DART AEROSPACE LTD	Work Order:	125050
Description: Crosstube Assembly, Mid Aft	Part Number:	D206-667-247
Inspection Dwg: D206-667-247 Rev: A		Page 1 of 2

DART AEROSPACE LTD HAWKESBURY, ONTARIO, CANADA	
DRAWING NO. D206-667-247	REV. A SHEET 1 OF 4
TITLE CROSSTUBE ASSY (206L MID AFT)	SCALE NTS

DRAWING NO. D206-667-247	TITLE CROSSTUBE ASS'Y (206L MID AFT)	REV. A	DART AEROSPACE LTD ENGINEERING ORDER		D.E.O. NO. D206-667-247-A-1	SHEET NO. SHEET 1 OF 1	SCALE NTS
DRAWN <i>Q</i>	CHECKED <i>ASS</i>	MFG. APPR. <i>KD</i>	APPROVED <i>JMP</i>		DE APPR. <i>#</i>		
DATE 11.07.15	DATE 11.07.20	DATE 11.07.21	DATE 11/07/21		DATE 11.07.21

PURPOSE:

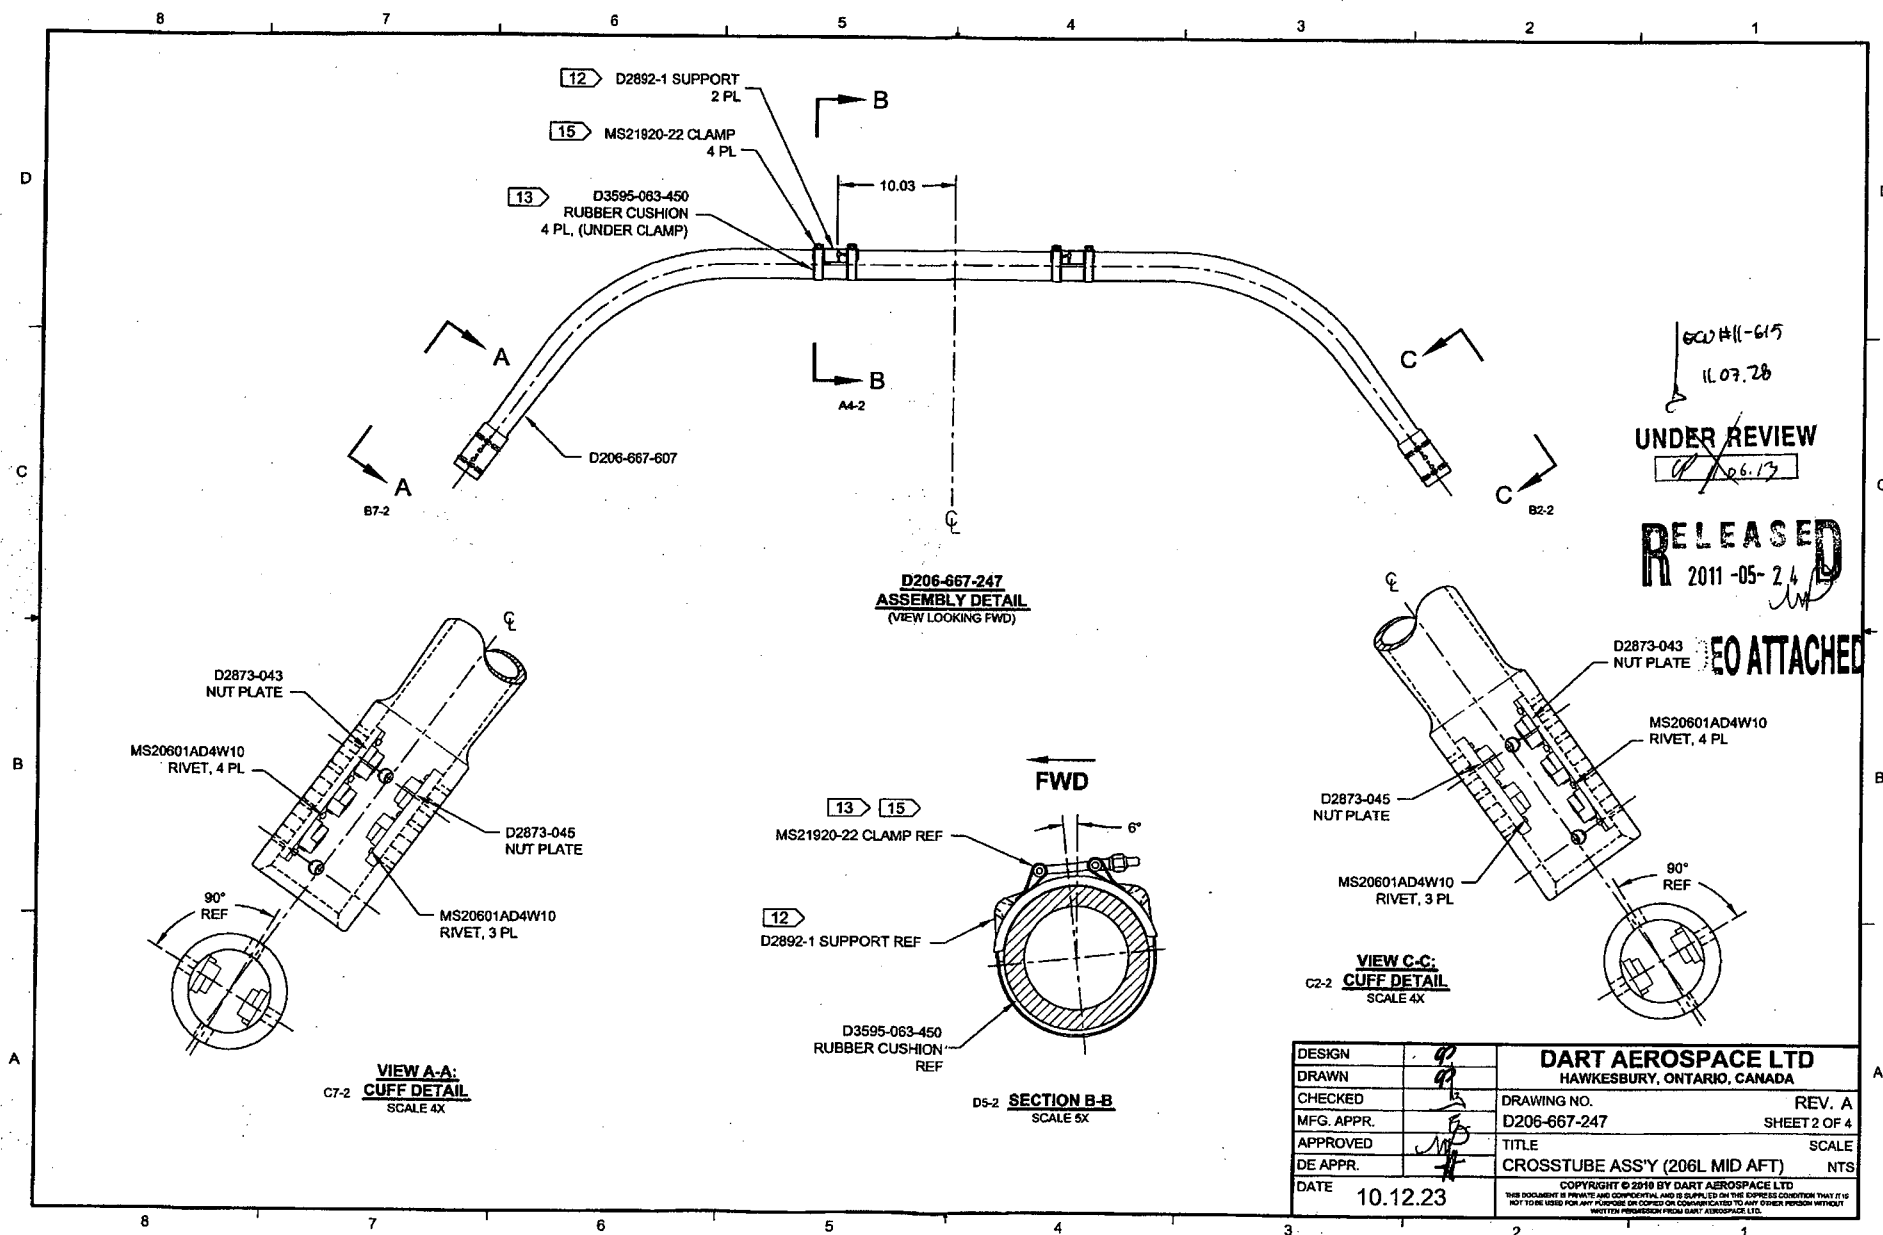
REPLACE MAGNOBOND WITH PROSEAL

Item	Qty -247	Part Number	Description
9	A/R	PROSEAL 890 B-2	SEALANT, AMS-S-8802 CLASS B-2

9	A/R	MAGNOBOND 6398	ROCKWELL SPECIFICATION RBO-120-023 ADHESIVE (TEXTRON/BELL SPEC. 299-947-100, TYPE II, CLASS 2 ADHESIVE)
---	-----	----------------	---

NOTE 12 & 15, SHEET 1 IS AMENDED AS FOLLOWS:

- 12) TO INSTALL D2892-1 SUPPORT: ABRASE MATING SURFACE OF SUPPORT AND CROSSTUBE WITH 180-GRIT SANDPAPER AND REMOVE RESIDUE WITH MEK (OR EQUIVALENT). APPLY A 0.04" TO 0.07" THICK LAYER OF PROSEAL 890 CLASS B-2 (OR AMS-S-8802 CLASS B-2) SEALANT TO MATING SURFACE OF SUPPORT.
- 15) TORQUE CLAMPS 80 TO 100 IN-LB. ENSURE AT LEAST 1.5 THREADS SHOWING IN SAFETY AND THAT NUT HAS NOT BOTTOMED-OUT AFTER TORQUING. **PRIOR TO PACKAGING, RE-CHECK TORQUE ON CLAMPS AFTER PROSEAL 890 SEALANT HAS CURED FOR 72 HOURS.**

- 12) INSTALL D2892-1 SUPPORT USING 0.03" TO 0.06" THICK LAYER OF MAGNOBOND 6398 PER QSI 015. LET CURE FOR 12 HOURS AFTER INSTALLATION AND PRIOR TO PACKAGING.
- 15) TORQUE CLAMPS 80 TO 100 IN-LB. ENSURE AT LEAST 1.5 THREADS SHOWING IN SAFETY AND THAT NUT HAS NOT BOTTOMED-OUT AFTER TORQUING.
